Minutes of an ordinary meeting of the Development Support Special Committee held via Zoom (electronic conferencing) on Wednesday, 15 April 2020 commencing at 6.00pm

<i>‘DEVELOPMENT APPLICATION NO.:</i>	DA2020053
<i>PROPOSAL:</i>	Residential (outbuildings – shed and carport) – variation to rear and side setback standards and outside required building envelope
<i>APPLICANT:</i>	Abel Drafting Services Pty Ltd
<i>LOCATION:</i>	11 Leighlands Avenue, Ulverstone
<i>ZONE:</i>	General Residential
<i>PLANNING INSTRUMENT:</i>	<i>Central Coast Interim Planning Scheme 2013</i> (the Planning Scheme)
<i>ADVERTISED:</i>	7 March 2020
<i>REPRESENTATIONS EXPIRY DATE:</i>	24 March 2020
<i>REPRESENTATIONS RECEIVED:</i>	Two
<i>42-DAY EXPIRY DATE:</i>	13 April 2020 – extension of time granted until 20 April 2020.
<i>DECISION DUE:</i>	20 April 2020
<i>PURPOSE</i>

<i>‘DEVELOPMENT APPLICATION NO.:</i>	DA2020045
<i>PROPOSAL:</i>	Residential (second storey extension) – variation to building envelope, front and side boundary setback standard, privacy for all dwellings and proximity of sensitive use to the railway line
<i>APPLICANT:</i>	ECLO Designs – Chloe Overton
<i>LOCATION:</i>	2 Hogarth Road, Sulphur Cre

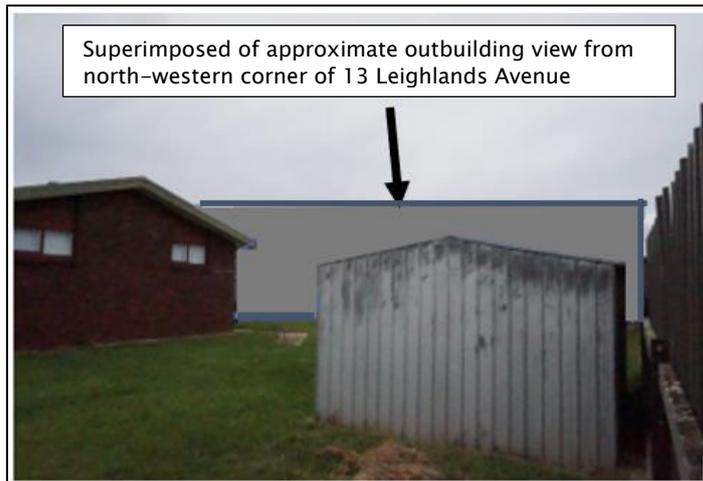
inside the dwelling along this boundary, the occupants can see the boundary fence, a small glasshouse located on 13 Leighlands Avenue, Ulverstone and a portion of the 9m long x 3m high solid wall location on 11 Leighlands Avenue, Ulverstone. This existing outbuilding is positioned approximately 10.5m away from the rear boundary and somewhat in line with the dwelling located at 13 Leighlands Avenue, Ulverstone. Therefore, the existing view currently observed from 13 Leighlands Avenue, Ulverstone is mainly openness along this boundary except for the boundary fence, small glasshouse, some of the existing outbuilding wall and a relatively small portion of the adjoining dwelling. This is typical within a developed General Residential zoned area.

This analysis of the existing amenity in terms of view along this boundary is validated with the images provided within the representation received from the occupants of 13 Leighlands Avenue, Ulverstone (refer to Annexure 3).

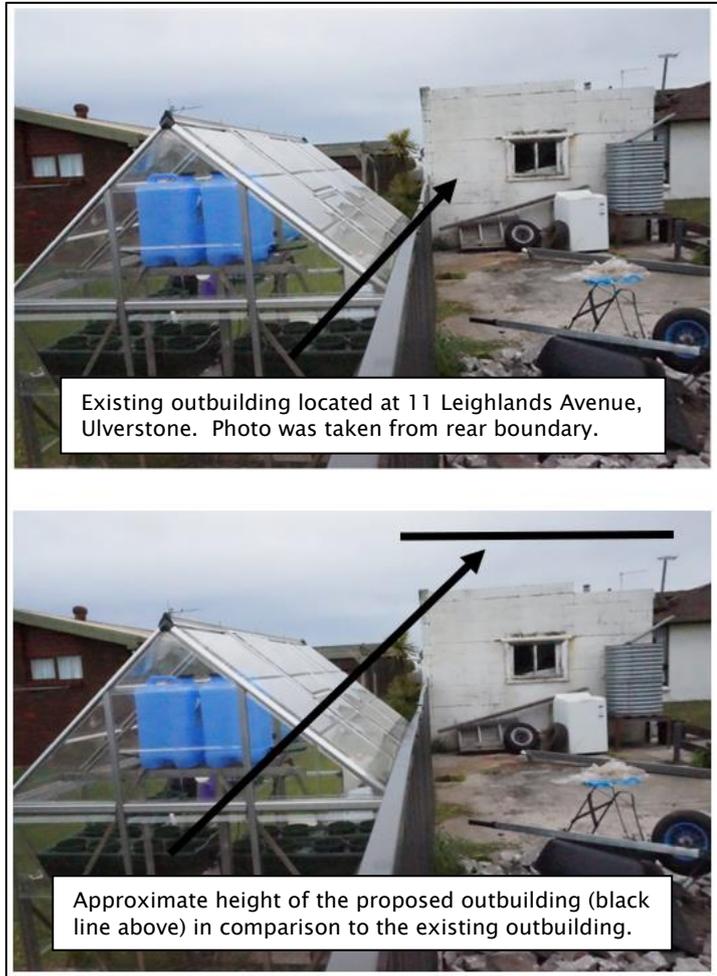
The proposed outbuilding (as shown in the image below) would be visually prominent along this boundary from 13 Leighlands Avenue, Ulverstone private open space area and some rooms inside the dwelling.

This analysis of the existing and proposed view along this boundary is validated with the images provided within the representation received from the occupants of 13 Leighlands Avenue, Ulverstone (refer to Annexure 3).

The solid 4.5m high x 16m wall along the boundary would increase the visual impact when viewed from 13 Leighlands Avenue, Ulverstone and would appear to be bulky and large scale in comparison to what is existing. The amenity when viewed from 13 Leighlands Avenue, Ulverstone would go from being a relative open area along this portion of the boundary to a large scale solid, blank facade with no articulation and modulation outbuilding.

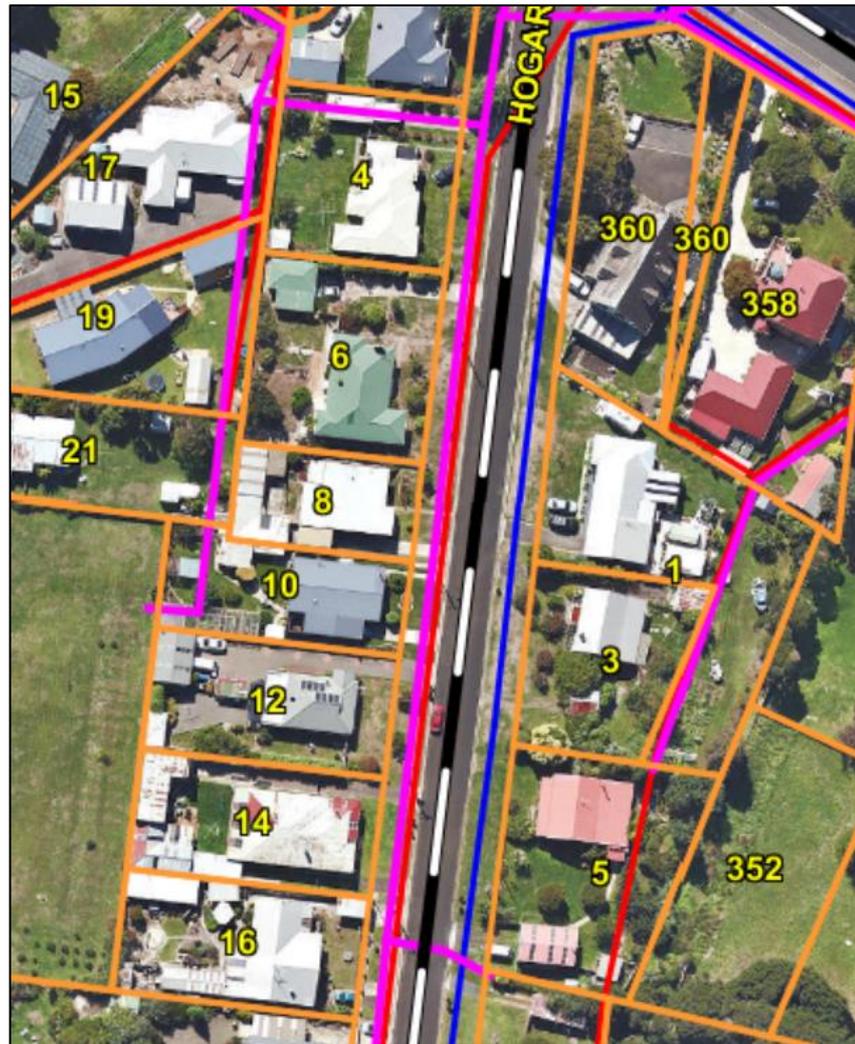
The proposed garage forming part of the proposed dwelling extension would extend into the primary frontage by an additional 2.6m, changing the primary frontage setback of the existing development to be from 6.2m to 3.37m from Hogarth Road. The location of other dwellings in Hogarth Road have setbacks that vary from 3.4m to be more than 4m. The proposed setback for the garage would be generally consistent with the existing dwellings in Hogarth Road, bearing in mind that a majority of the dwellings do not demonstrate the required 4.5m primary setback frontage as required under the Planning Scheme (refer to aerial map layout).

The proposal seeks a variation to this standard seeking to construct the proposed garage within 3.3m of Hogarth Road in front of the existing dwelling. An exercise of discretion is required to determine if a Permit may be issued.
